Zoning & Subdivision Committee

Thursday, March 11, 2021, 12:30 pm

Staff Report – Dublin Green

**Subject: Dublin Green – Preliminary Plat
Review Comment Letter**

VIRGINIA MILITARY SURVEYORS AND SURVEYORS
JEROME TOWNSHIP, FRANKLIN COUNTY, STATE OF OHIO
PRELIMINARY PLAN
FOR
DUBLIN GREEN
EXISTING CONDITIONS PLAN - 2016

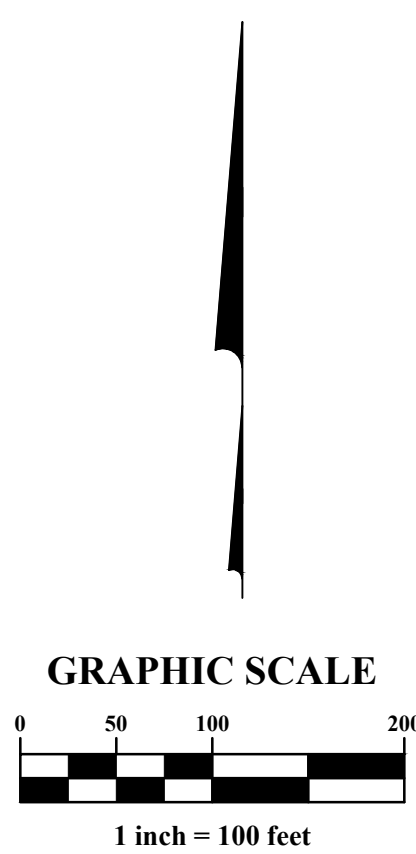
- 2) It is my understanding that page 1 labeled "Existing Conditions Plan – 2016" is intended to depict the site as it was during that year. If so, the labels of the zoning districts are incorrect. All labels indicating "PUD" should be labeled "PD" per Chapter 500 of the Zoning Resolution and the Official Zoning Map. Parcel #150031004000, 150031015000 and 150031016000 are labeled "U-1". Per Chapter 425 and the Official Zoning Map these parcels should be labeled "RU".

- Provide a typical title sheet with all applicable information (location map, index map, sheet index, standards, easement language (if known), development summary, etc.)

PRELIMINARY PLAT FOR DUBLIN GREEN SITE PLAN

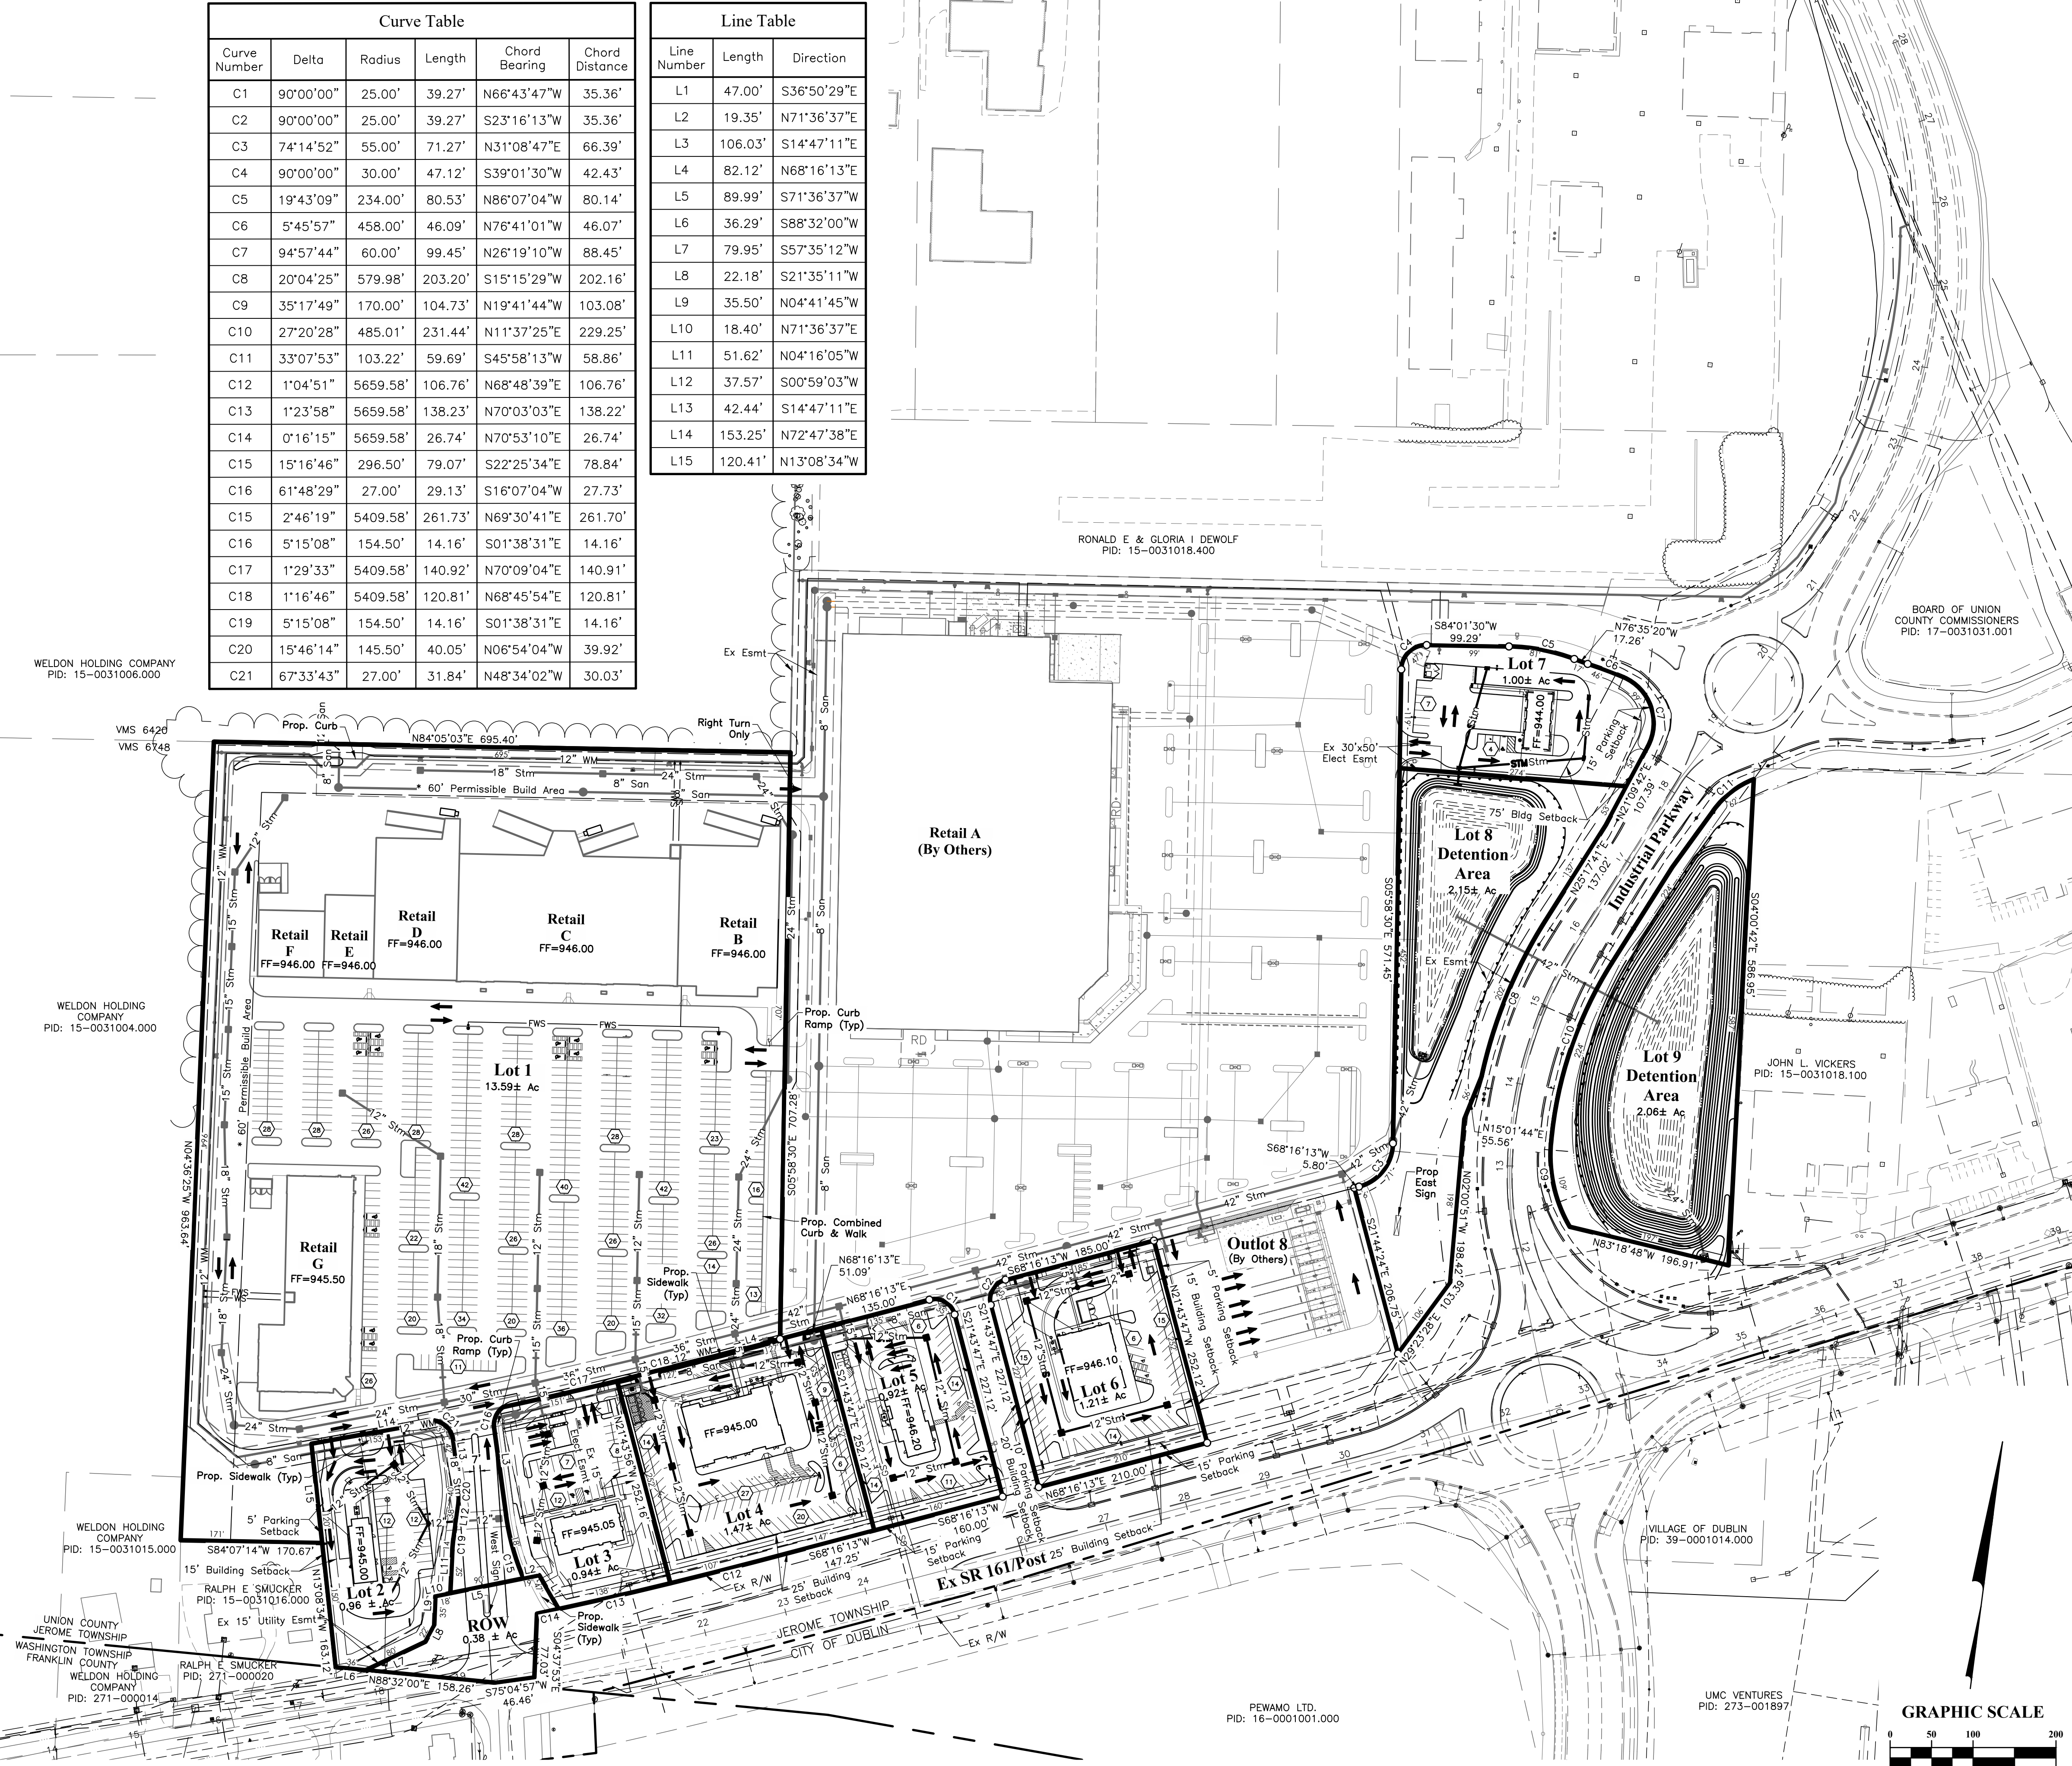
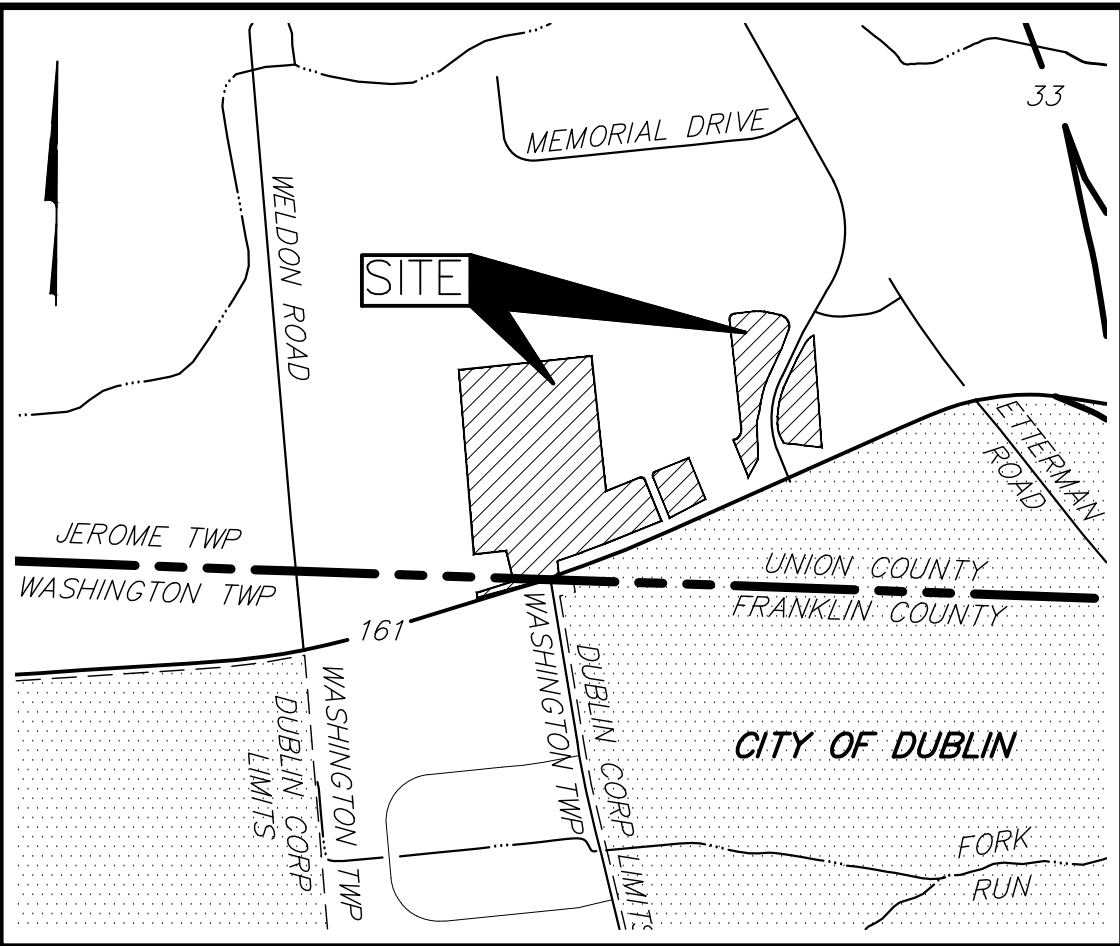
- 4) The unnumbered notes on page 2 "Site Plan" indicate "Permissible build area as long as parking ratios and restrictions of PUD text are maintained." This is not consistent with terms defined in the Zoning Resolution. The same intent would be conveyed by the following note: "Site development subject to compliance with additional provisions of the approved PD District regulation text." Zoning staff would also support numbering of these notes, assuming this is acceptable to other review agencies as well.

- Please turn off non-applicable information to make the sheet more legible
- Clearly show and dimension all easements.
- Clearly label all easements.
